Re: Code Violation
129 W. 1st St.
Salida, Co. 81201

MEMORANDUM

RE: **Unique Theater Inspection**
SGM Project No. 2008-213.001 Phase 023

**RE: Environmental Health assessment of the vacant building located at 125-131
West First Street in Salida Colorado**

PLAN FROM REFERENCE 1

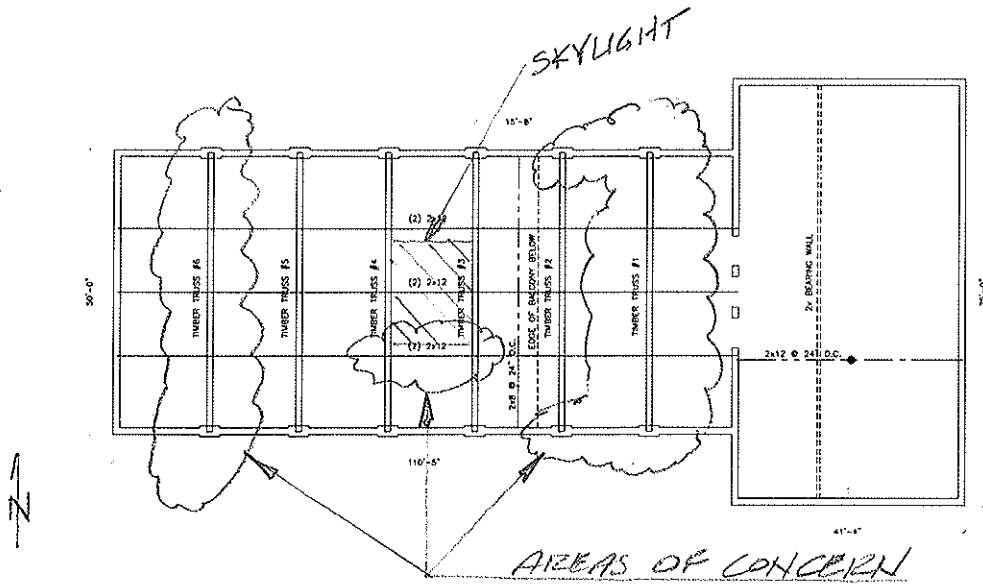
Both the interior and exterior of the building were inspected. There existed significant amounts of debris on the floor of the main theater, so not all areas were observable or accessible. A previous report (Ref. 1) identified the main roof trusses as Truss #1 thru #6, numbered from east to west, assuming the theater faces east. Truss #2 thru #5 had shoring in place, as submitted in March 2007 (Ref. 2). Holes had been cut in the roof over the shoring locations (2 locations for each truss) in order to install the shores. It was reported these holes have remained open to the weather since the spring of 2009. As a result of our inspection, we have identified the following areas of concern, as shown on the building plan (Attachment 1):
